P. O. A. D. P.

DEVELOPMENT PLAN

SAN ANTONIO WEST BUSINESS CENTER
63.6496 ACRES OF LAND, TRACT "A" and
46.1607 ACRES OF LAND, TRACT "B", N.C.B. 8669
SAN ANTONIO, BEXAR COUNTY, TEXAS

RE: M.A.U.C. POADP #246

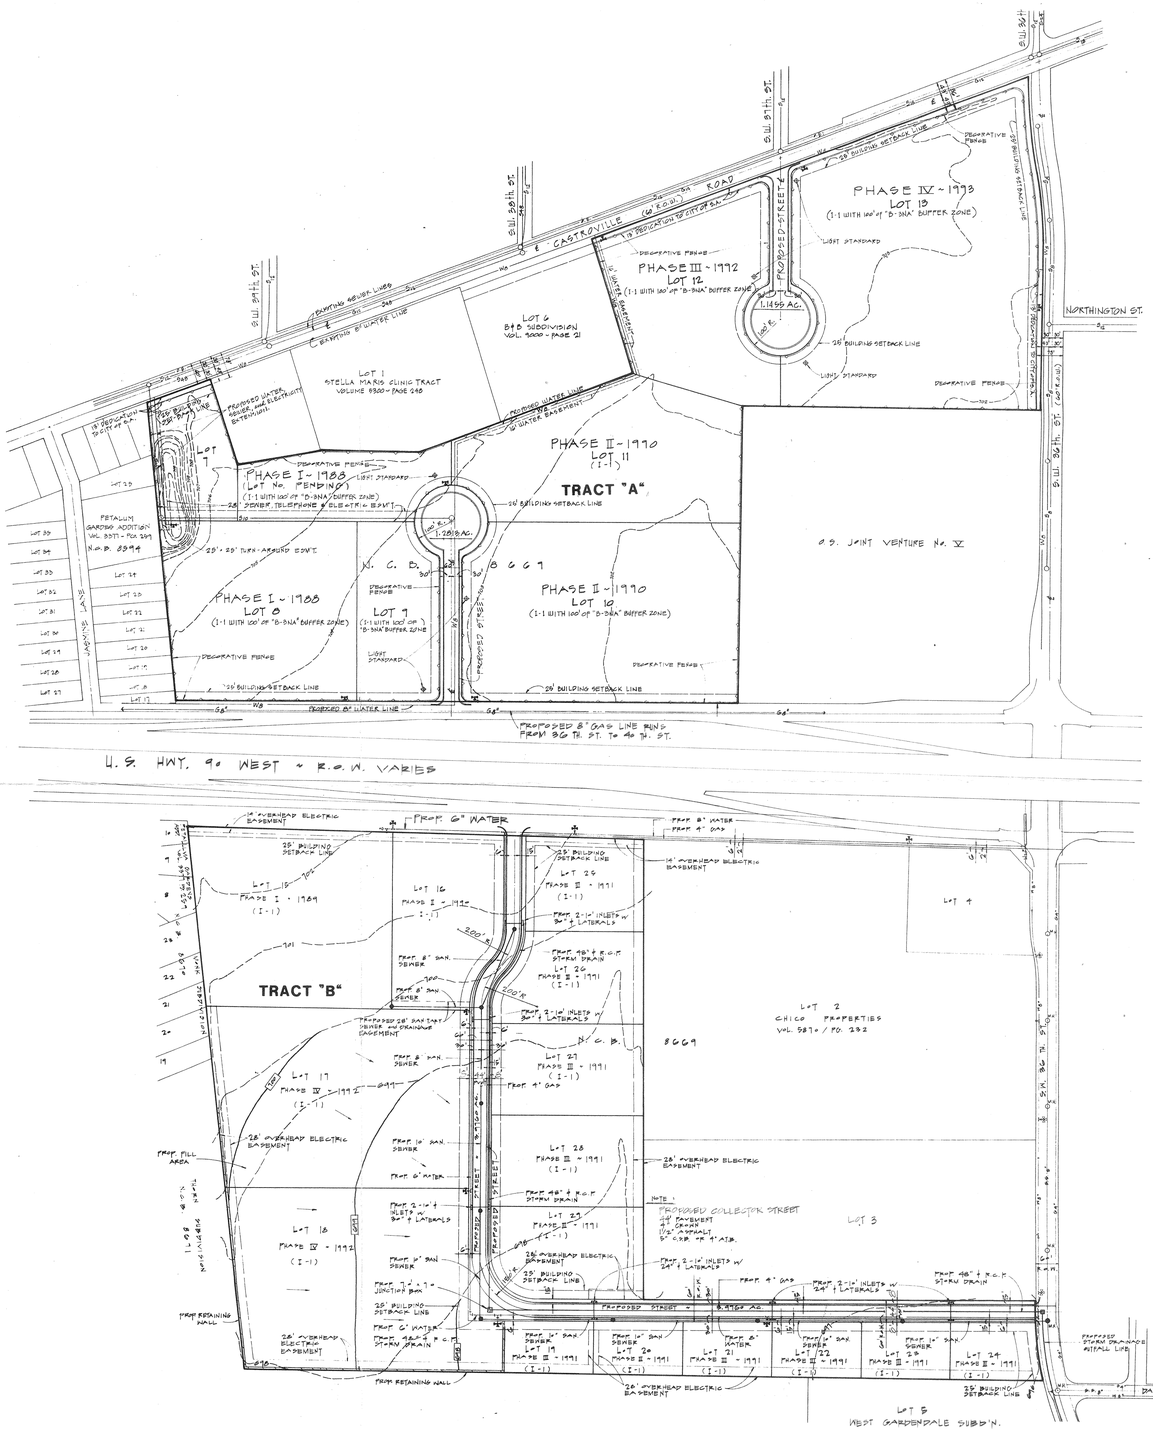
The Development Review Committee has reviewed and accepted your revised plan for the M.A.U.C. site except as noted in the paragraph below. The plan has been assigned File #246 for future reference.

Staff notes that Section 35-A204, Table V, of the Unified Developmment Code, requires a 400' centerline radius for collector streets. It is therefore recommended that your staff work with the Traffic Engineer to bring your proposed collector street to standards.
